**Environmental
Protection Agency**

July 6, 2011

RE: LAKE COUNTY
CITY OF MENTOR
S.R. 2 B/W S.R. 306 & FERN DRIVE
NPDES PERMIT NO. OHC000003
OHIO EPA PERMIT NO. 3GC04762*AG
CONSTRUCTION STORM WATER

Figure 5. Off site tracking of sediment from vehicles is visible on Center Street.

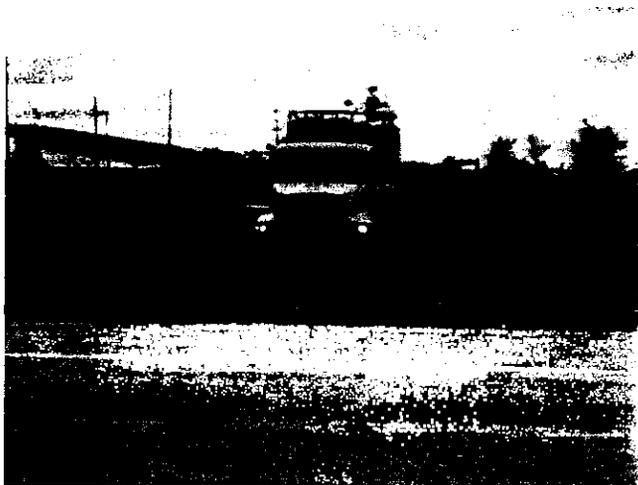
- There were signs of sediment tracking onto Center Street from the staging areas. Please be sure to construct rock entrances to these areas with the specifications detailed in the SWP3 to prevent mud from being tracked from vehicles onto Center Street (See Figure 5).
